Access Compliance Report

Public Rights-of-Way

Intersection ID: 30314	Main Street: ROCKET_LN	Cross Street: SHINKANSEN_DR	Location: SW
ADA ID: 8FCEFBAC0597	Ramp Type: PerpDiag	Initial Pass/Fail: Fail	Overall Compliance: No
		Severity Score: 25

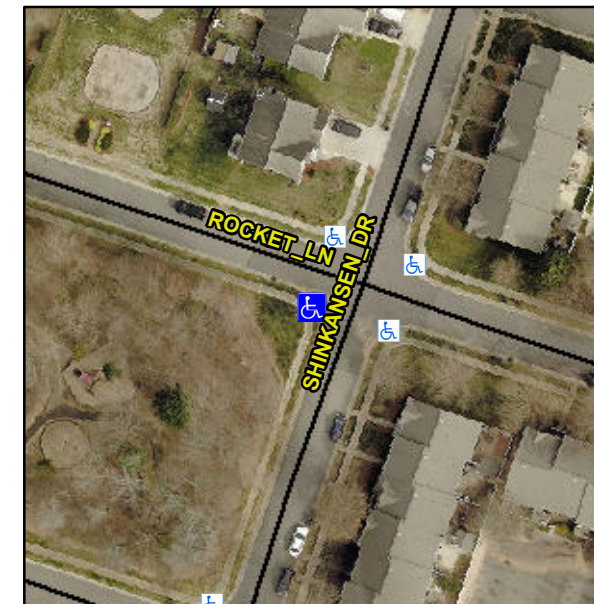
Not Found, R304.5.3

Compliance	Description	Data	Compliance	Description	Data
N/A	Ramp Length (in)	44.0	Yes	Ramp Slope (%)	6.5
Yes	Ramp Width (in)	48.0	No	Ramp XSlope (%)	7.9
N/A	Flare Type LT	N/A	N/A	Flare Type RT	N/A
N/A	Flare Slope LT (%)	N/A	N/A	Flare Slope RT (%)	N/A
N/A	Flare Traversable LT?	N/A	N/A	Flare Traversable RT?	N/A
N/A	Landing Length (in)	N/A	N/A	DWS Provided?	N/A
N/A	Landing Width (in)	N/A	N/A	DWS Contrast?	N/A
N/A	Landing Slope (%)	N/A	N/A	DWS Length (in)	N/A
N/A	Landing X Slope (%)	N/A	N/A	DWS Full Width?	N/A
N/A	Landing Curb? (Y/N)	N/A	N/A	DWS Offset (in)	N/A
N/A	Shared Landing?	N/A			
N/A	Gutter Ponding?	N/A	N/A	Gutter Slope (%)	N/A
N/A	Gutter Lip Ht (in)	1.0	N/A	Gutter X Slope (%)	N/A
N/A	Painted X Walk1?	No	N/A	Painted X Walk2?	No
	X Walk 1 Direction	To SE		X Walk 2 Direction	To NE
N/A	X Walk 1 Width (in)	N/A	N/A	X Walk 2 Width (in)	N/A
	X Walk 1 Slope (%)	5.3		X Walk 2 Slope (%)	0.7
	X Walk 1 X Slope (%)	3.7		X Walk 2 X Slope (%)	5.3

Remove & Replace Curb Ramp With Two New Directional Ramps or Equivalent.
